Effect of weak and soft storeys on seismic performance of reinforced concrete frames with unreinforced brick infills

Discussion by N. Subramanian

Replies by Patnala V.S. Neelima and R. Pradeep Kumar

This has reference to the paper titled 'Effect of weak and soft storeys on seismic performance of reinforced concrete frames with unreinforced brick infills', authored by Patnala V.S. Neelima and R. Pradeep Kumar, published in The Indian Concrete Journal (Vol. 90, No. 2, pp. 19-26).

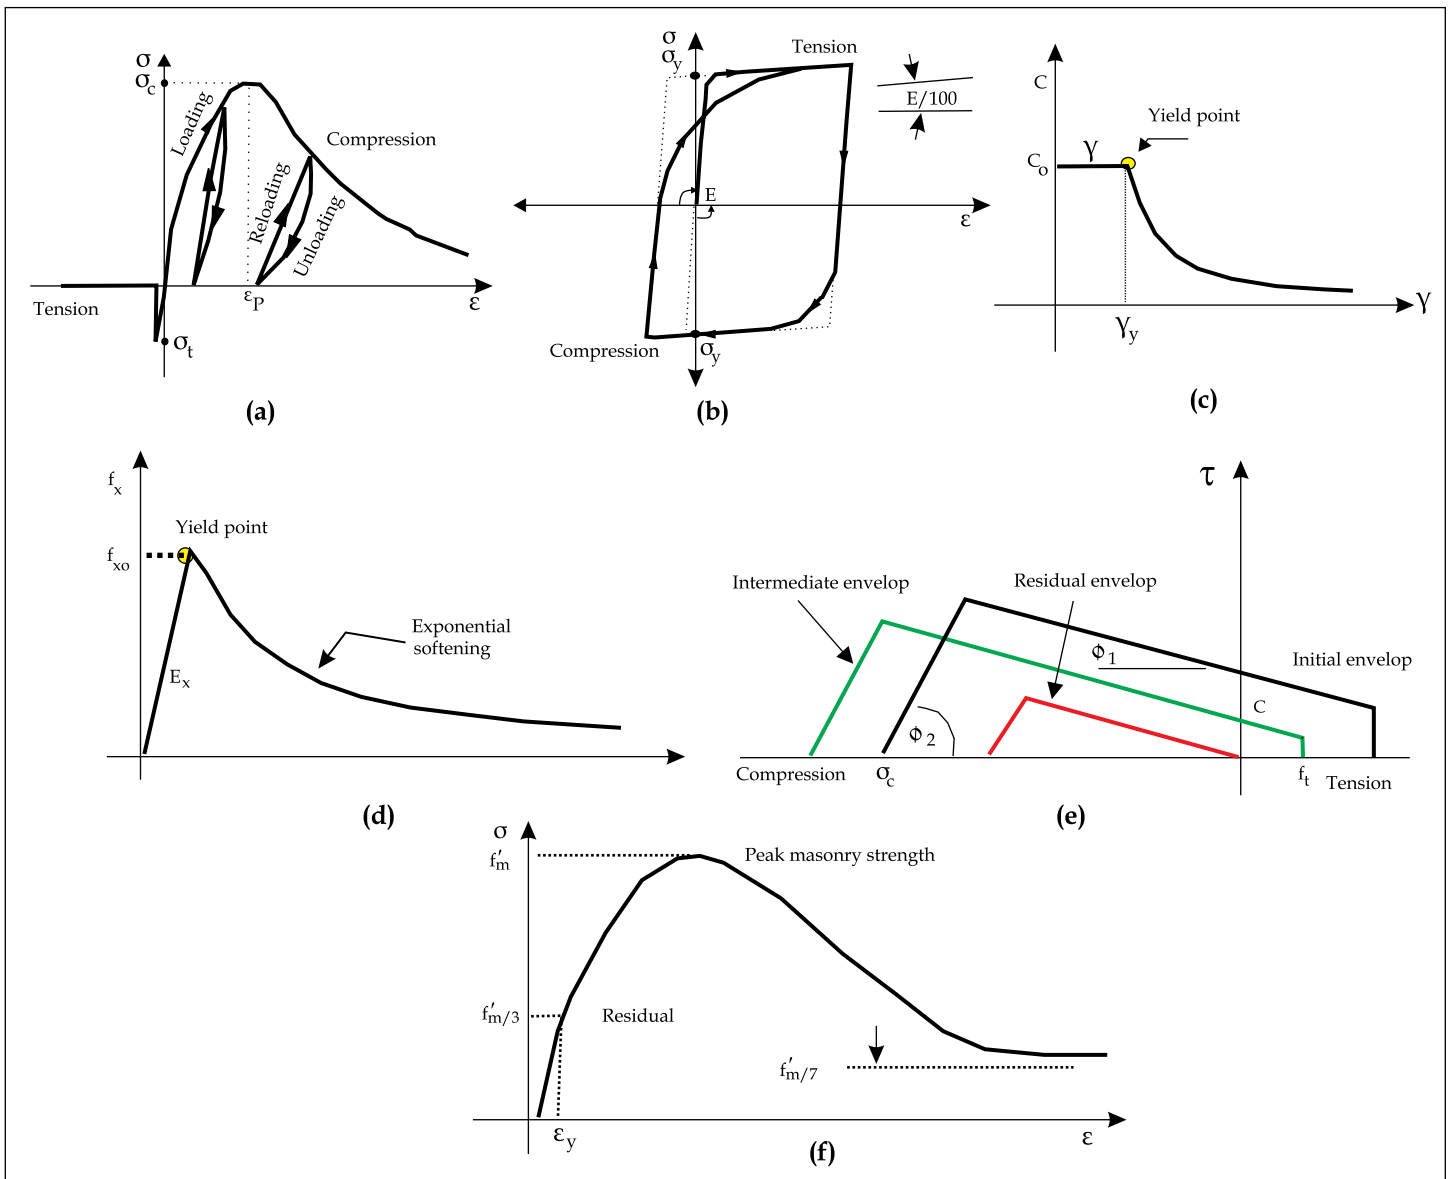
The discussor is not conversant with the Applied Element Method (AEM) used by the authors. However, it may be interesting if the authors explain the interface condition, between the infill brickwork and the concrete frame, considered in the analysis. It is usually better to conduct experimental work to confirm the assumption made in the complex computer analysis.

Reply: For brick masonry, the material model used was a composite model that takes into account the brick and mortar with their respective constitutive relation with elastic and plastic behavior of hardening and softening. Brick springs were assumed to follow principal stress failure criteria with linear elastic behavior. Once the bricks reach elastic limit, normal and shear stresses are not transferred through cracked surface in tensile state. Failure modes that come from joint participation of unit and mortar in high compressive stress is considered by liberalized compression cap. The cohesion and bond values are constant till the stress first time when stress exceeds the respective failure envelopes. Figure 1 (a), (b) shows the material models used for concrete [10] and steel [10], (c), (d), (e) and (f) show the cohesion degradation [1], bond degradation [1], failure envelope [1] and softening model [11] defined at the brick masonry joint. For further details on the method please refer to the research paper in references [5] in the paper under discussion.

Figure B. Comparison of pushover curves for structures modeled with infill walls using FEM and AEM

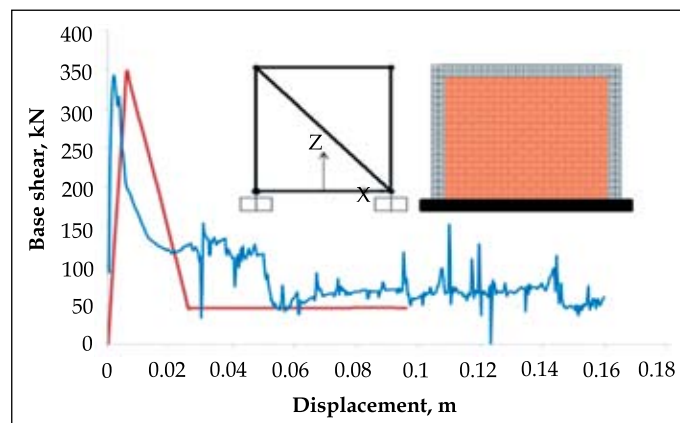
mechanism is changed from frame action to predominant truss action and the columns will have increased axial forces but with reduced bending moments and shear forces (Murty and Jain, 2000). Hence, it may be easier to find the behaviour of these frames, by substituting the infill wall by diagonal struts. Again, several formulae are available for idealizing these brick struts. One such idealization is given in Clause B-3.3 of the IS 800:2007.

Reply: As the finite element method is based on the assumption that the material is continuum, limitations exist in representation of cracks and separation between elements. The finite element strut modeling assumes the infill wall as a single strut by which only few parameters responsible for the seismic behavior can be assessed. Figure 2 show the comparison between the strut modeling and the AEM modeling.

Figure C. Basic strategy of earthquake design: Calculate maximum elastic force and reduce by a factor to obtain design forces (Ref: "Some Concepts in Earthquake Behavior of Buildings", by C V R Murty et al, GSDMA, Govt. of Gujarat)

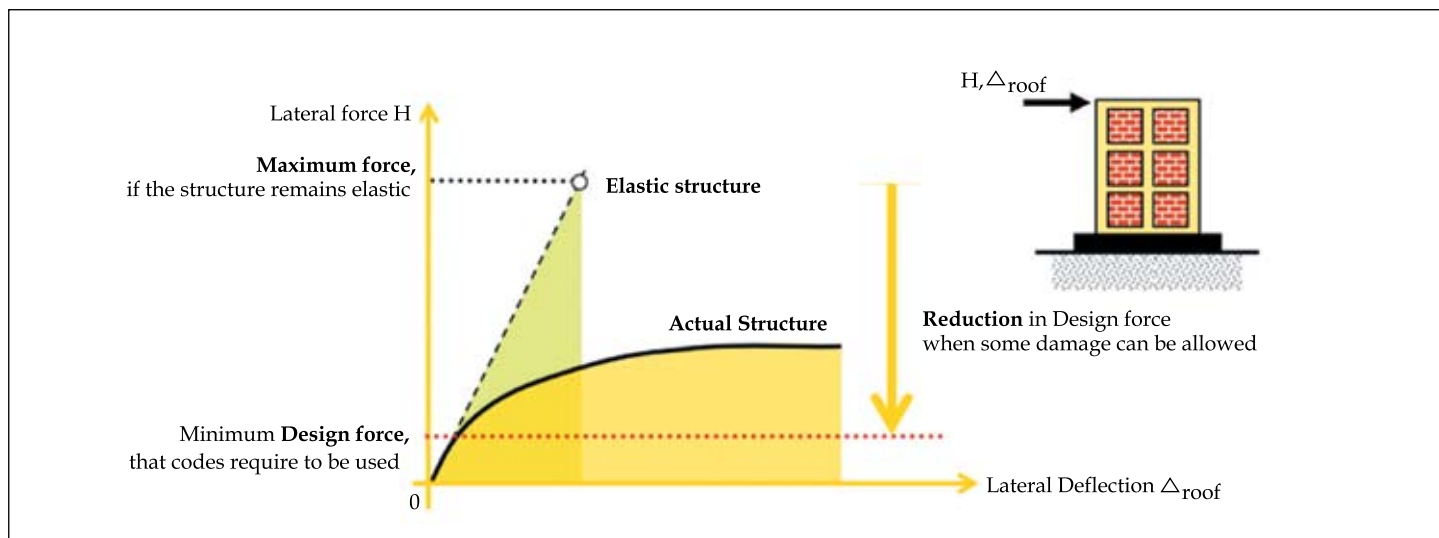
In Table 2, they have shown that the maximum base shear for the structure with soft storey has a maximum base shear of only 160 kN, as compared to 4673 kN for the structure without soft storey. Similarly, the modified structure considering 2.5 times the shear and moments, as per Clause 7.10.3(a) of IS 1893(part 1):2002, has a maximum base shear of only 578 kN. Design seismic base shear is dependent on A_h (design horizontal acceleration spectrum value) and W (seismic weight of the building) only. Will the removal of infill wall only in the GF, result in so much reduction in the design seismic base shear?

Reply: According to the code, the formula for base shear represents the design base shear but not the maximum base shear. Moreover, the design base shear given in code is obtained from linear analysis. The nonlinearity of the building is represented by a factor 'R' response reduction factor. Whereas the maximum base shear of the building is obtained from non linear static pushover analysis. This can be clearly illustrated in Figure 3.
